Project Description

[This submittal requesting Certificate of Appropriateness review of a proposed infill structure in the Union Hill National and City Historic District accompanies a separate but associated and previously approved application for demolition of the non-historic and non-contributing 1-story structure at 2416 Jefferson Ave. The structure described in this application is intended to replace the non-historic structure which is under the same ownership. The project in totality encompasses the majority of the triangular block and comprises a significant redevelopment of urban street wall at this vital location.]

Revisions to Building Features based on previous CAR and neighborhood comments

3rd level and recessed wall cladding

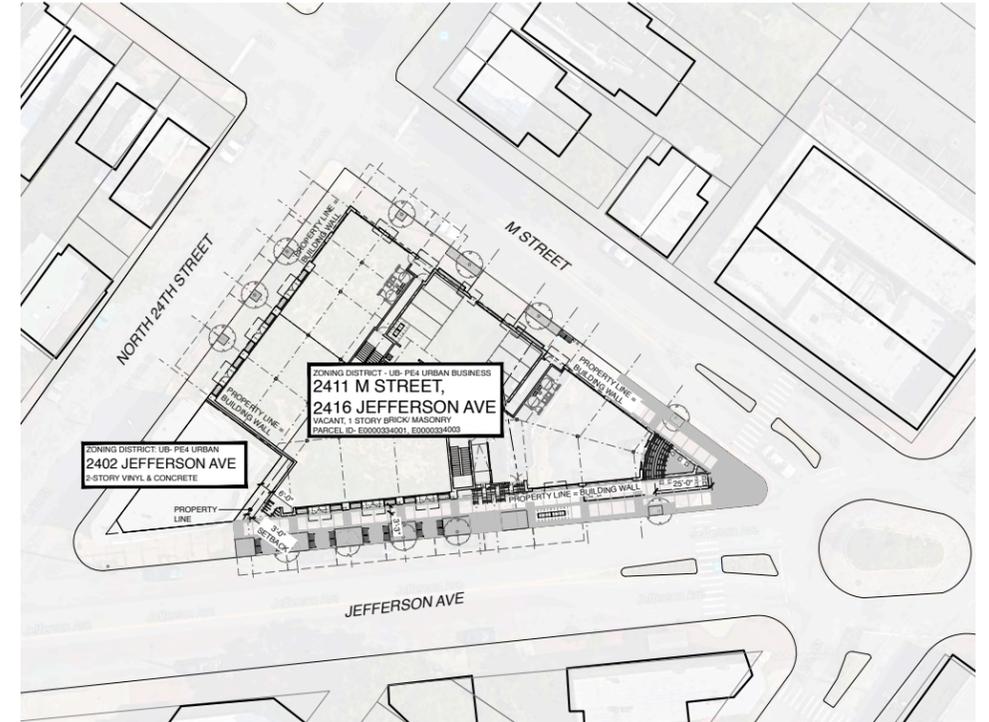
In contrast to earlier presentations that depicted this material as being very light in color, this material color has been revised to be darker in color and more recessive in character.

Rooftop Railing locations and Rooftop Room Size

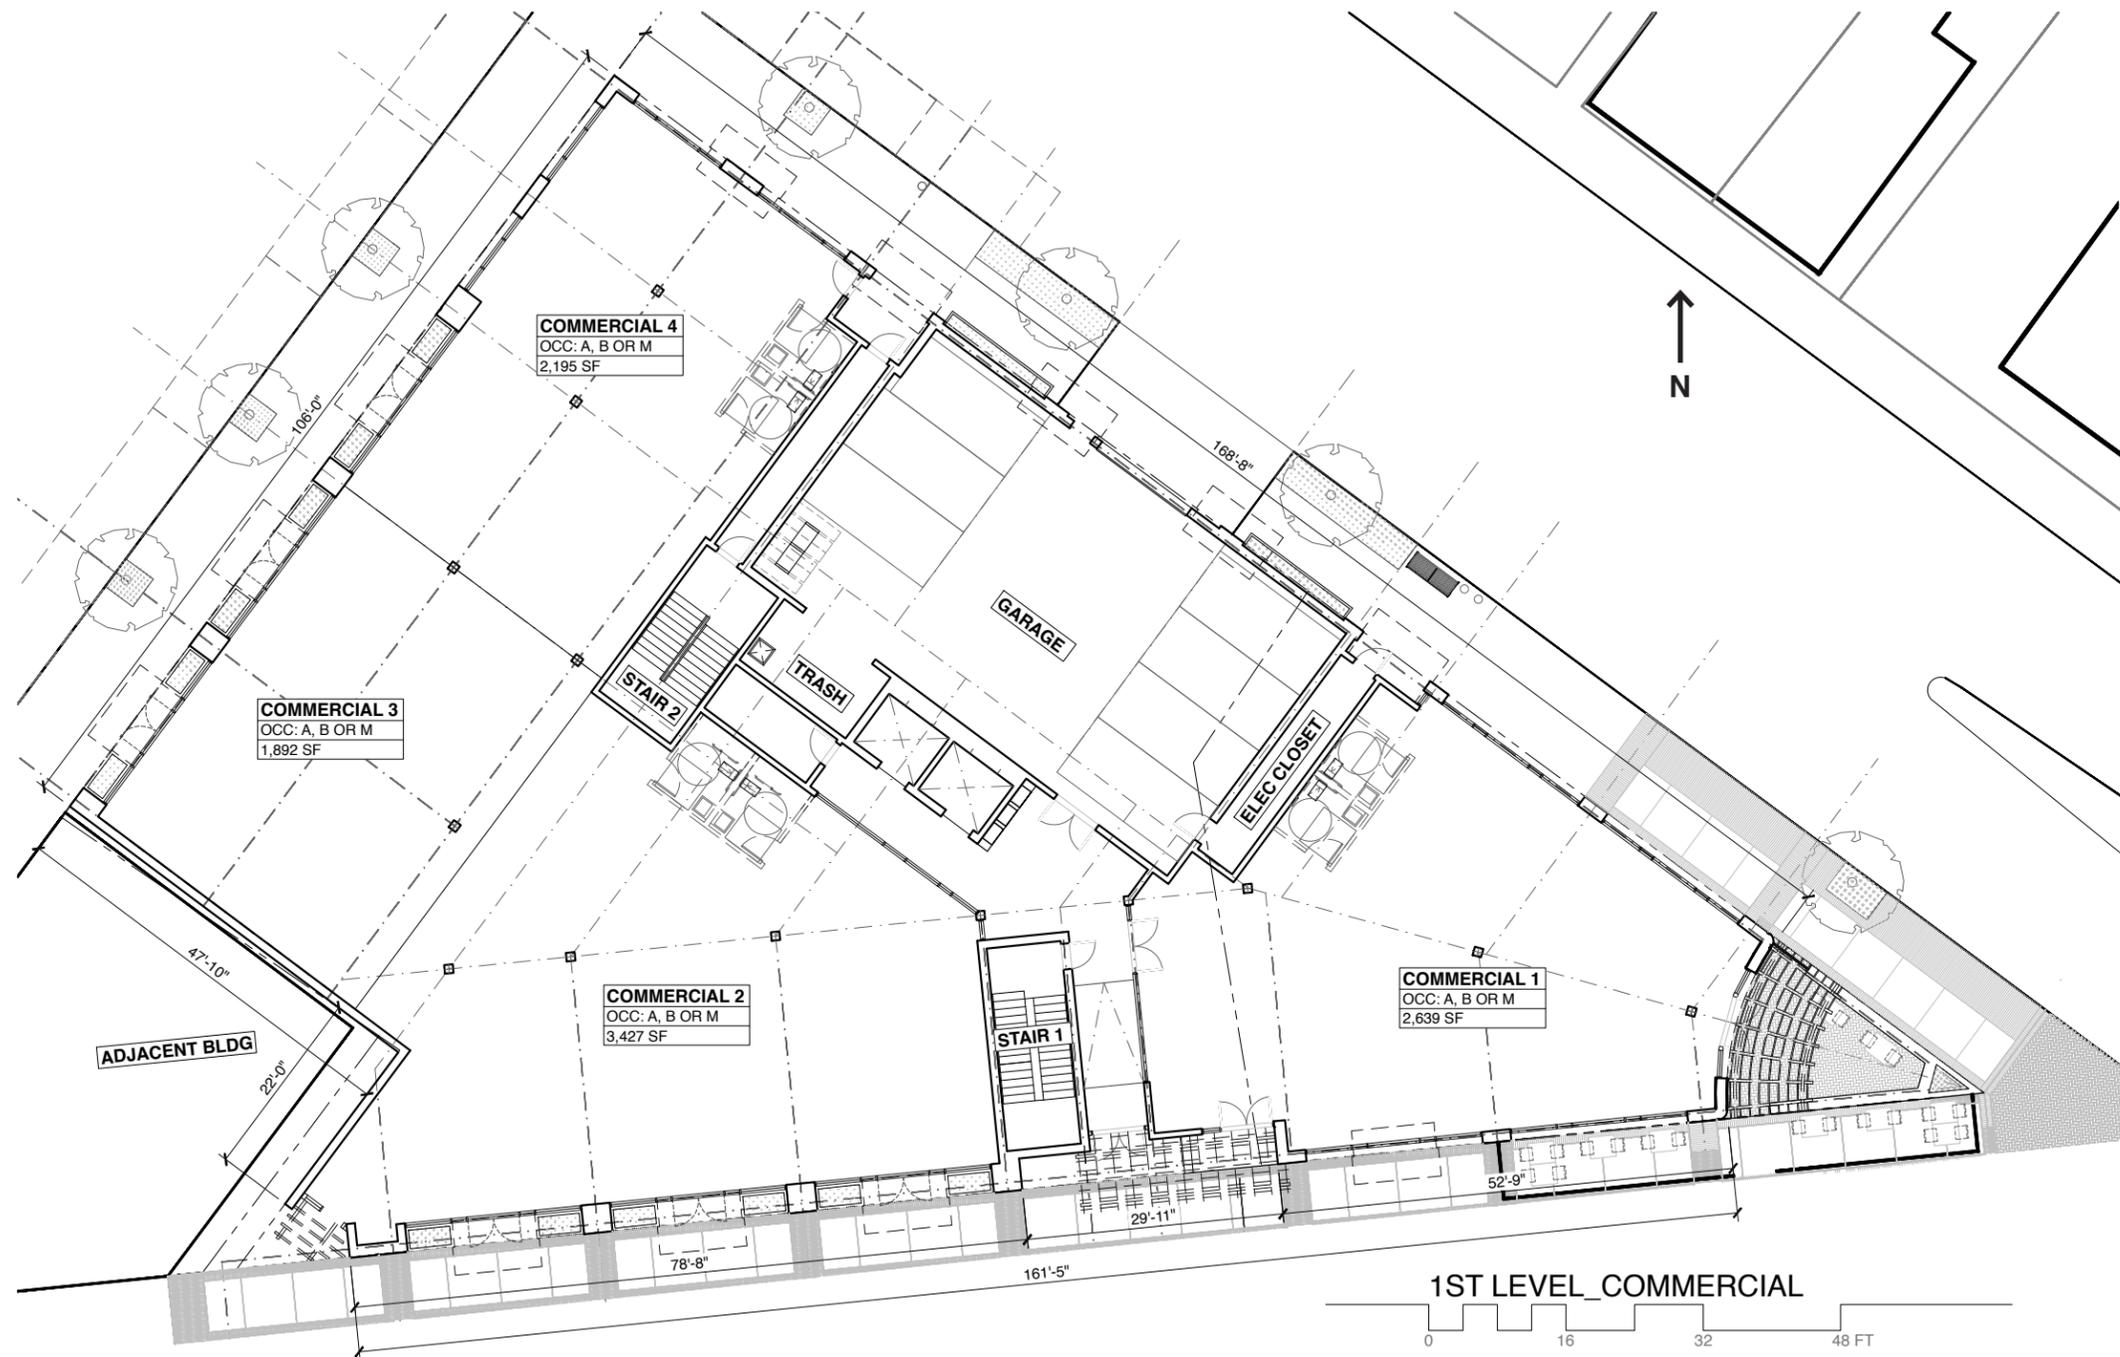
The Rooftop room and proposed surrounding deck area have been reduced in size and moved away from the street walls.

ROOF LEVEL COMMERCIAL/TERRACE

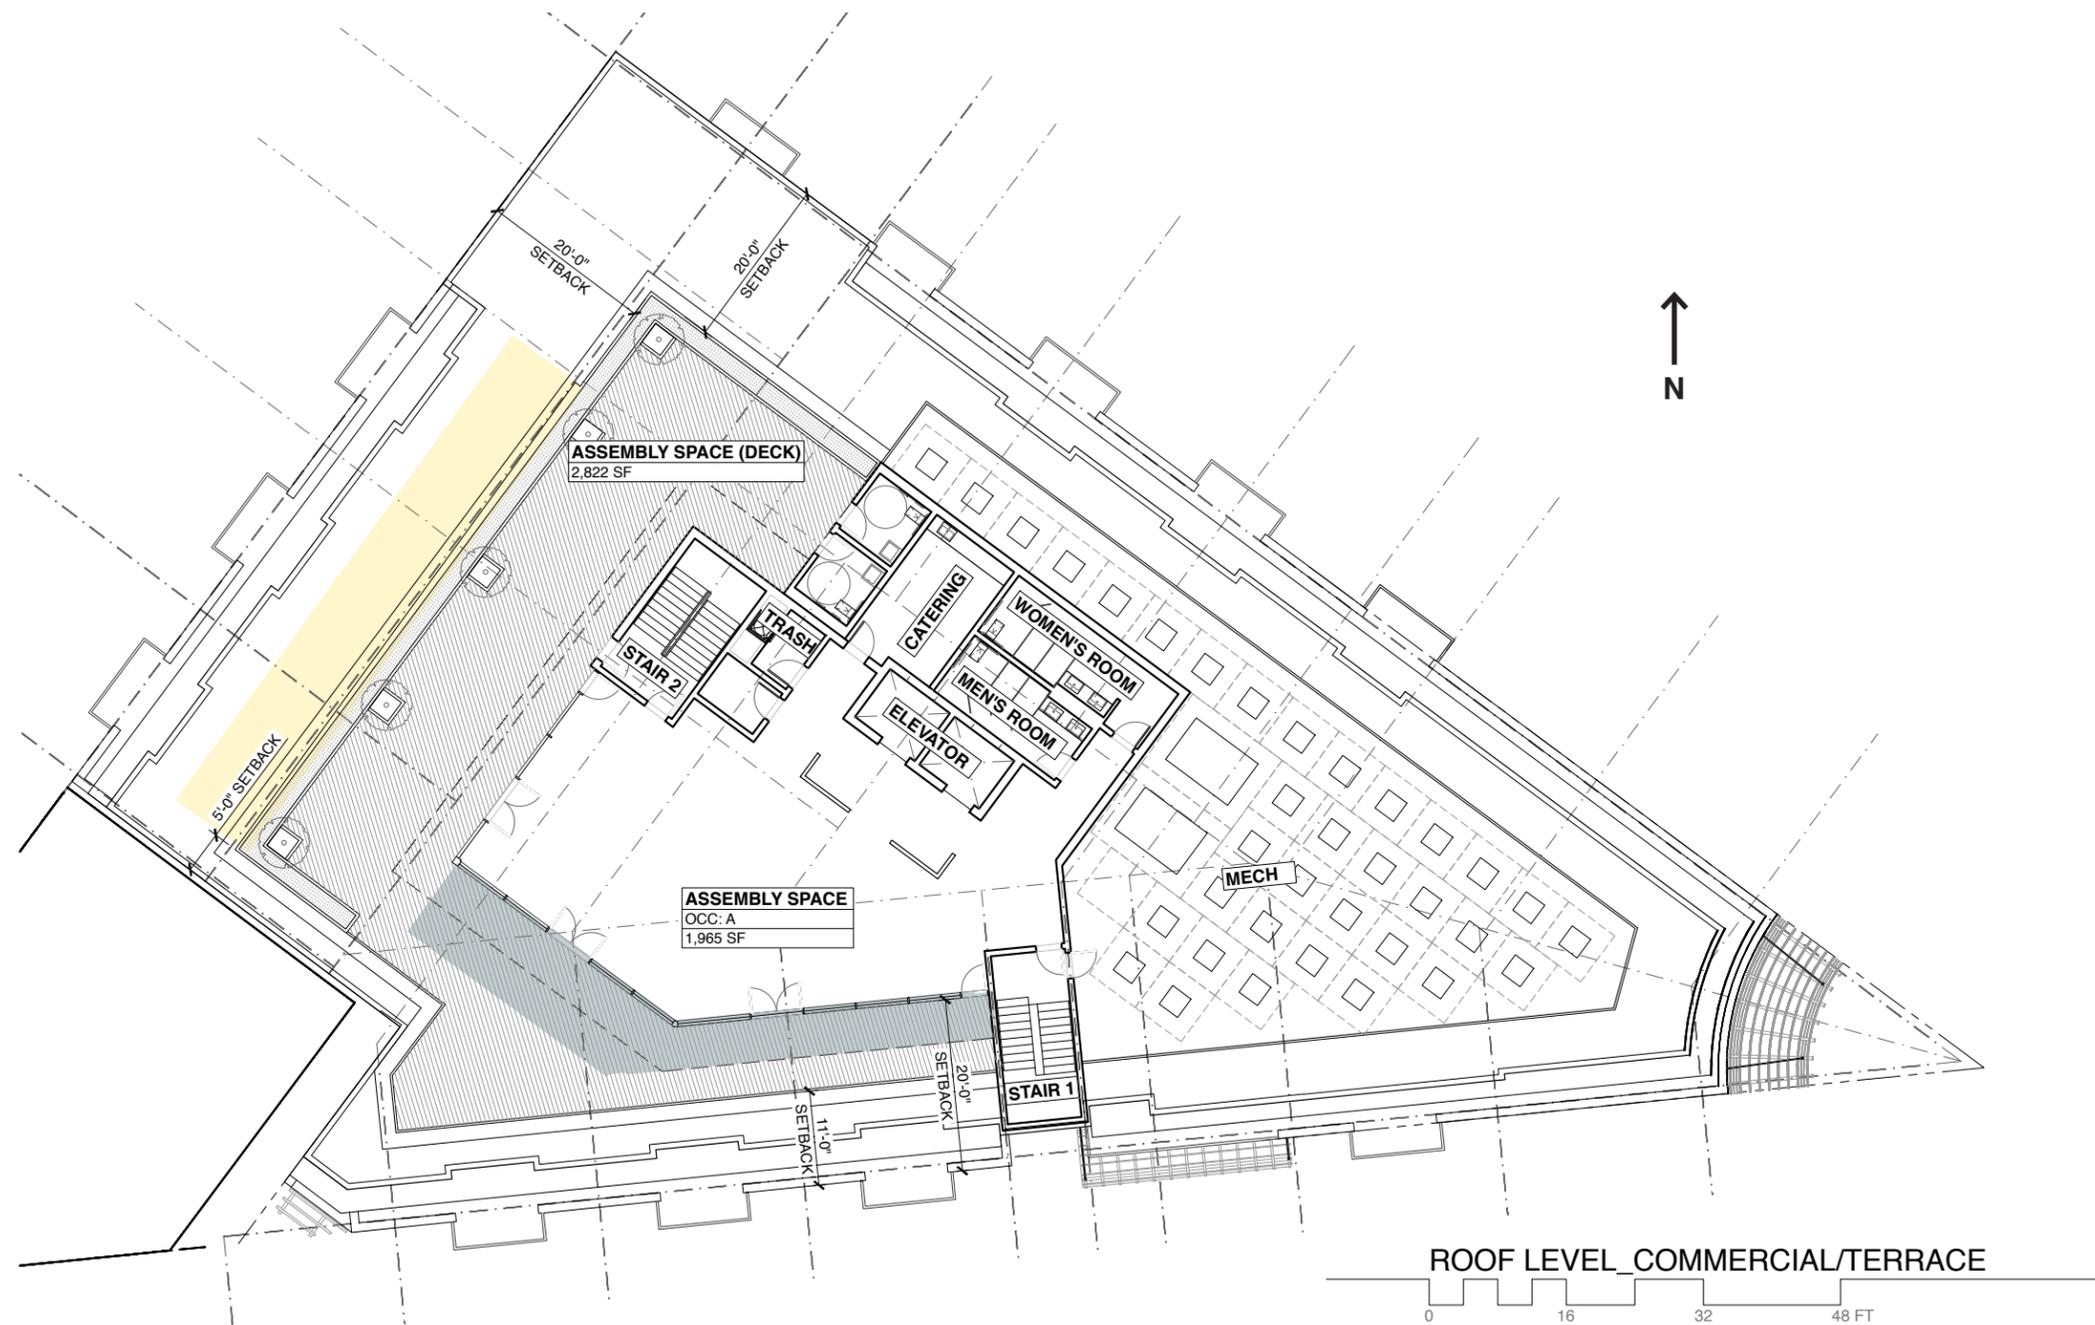
0 16 32 48 FT
 [light yellow area indicates reduction in exterior decking
 light blue area indicates reduction in proposed rooftop interior space]
